STAFF REPORT

Re: Urbana – Final Subdivision Plat Request

Application No.: 2024-0129-SUB
Applicant: Jacob Ballstaedt of Garbett Homes
Project Location: Approximately 285 W. River Chapel Road
Current Zoning: RM2 (Multiple-Family Residential) Zone
Acreage: Approximately 3.9 acres (approximately 169,884 sq. ft.)
Request: Request for approval of a Final Subdivision Plat for a 30 lot subdivision.

EXHIBIT A DEPARTMENT REVIEWS

EXHIBIT F
FINAL SUBDIVISION PLAT

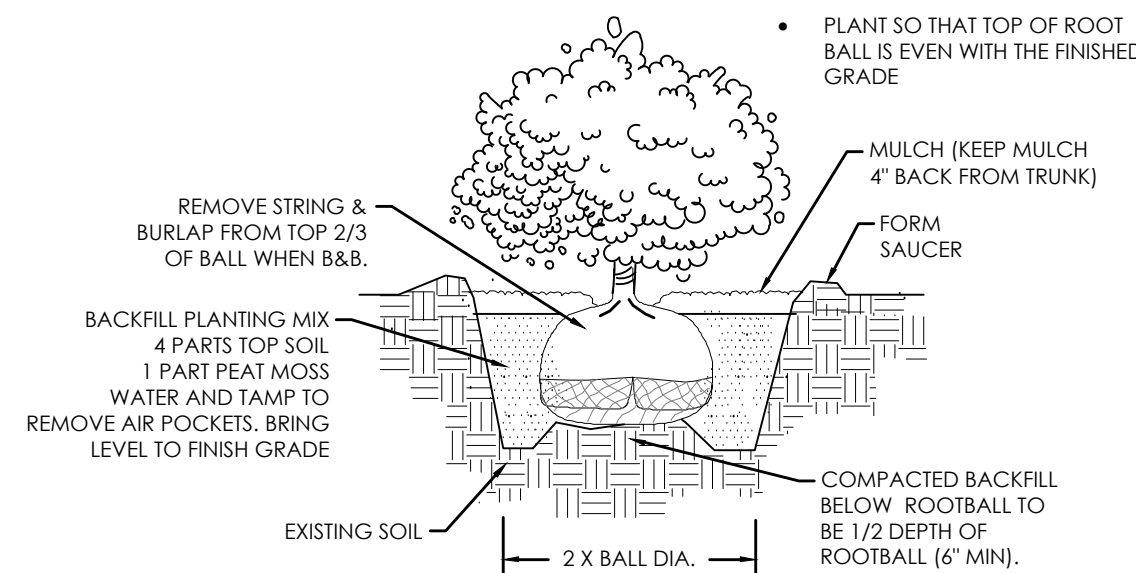
1. Include the note from Section 17-5-060(B)(1)(a) of the DCMC on the Final Mylar Plat.

1. **Fire Department Access is required.** An unobstructed minimum road width of 24' feet exclusive of the shoulders and a minimum height of 13'6" shall be required. The road must be designed and maintained to support the imposed loads of emergency apparatus. The surface shall be able to provide all weather driving capabilities. The road shall have an inside turning radius of 28'. There shall be a maximum grade of 10%. Grades may be checked prior to building permits being issued.
D103.6.1 Roads 20 to 26 feet in width. Fire lane signs as specified in Section D103.6 shall be posted on both sides of fire apparatus access roads that are 20' to 26' wide.

2. **D103.6 Signs.** Where required by the fire code official, fire apparatus access roads shall be marked with permanent **NO PARKING—FIRE LANE** signs complying with Figure D103.6. Signs shall have a minimum dimension of 12' wide by 18" high and have red letters on a white reflective background. Signs shall be, posted on one or both sides of the fire apparatus road as required by Section D103.6.1 or D103.6.2. **NO PARKING FIRE LANE signs shall be placed every 250 feet. Please show on plans.**

3. **Fire Hydrants are required.** Hydrants are required to be spaced at 450' as the hose lays not as the crow flies for this project. Fire Flow of 2,000 GPM @ 20 p.s.i. residual pressure. All fire hydrants are required to be operational and unobstructed at all times throughout the project. If at any time a hydrant needs to be shut down and made inoperable the Fire Marshal shall be notified immediately. The three proposed hydrants are acceptable to the fire department. **This has been met.**
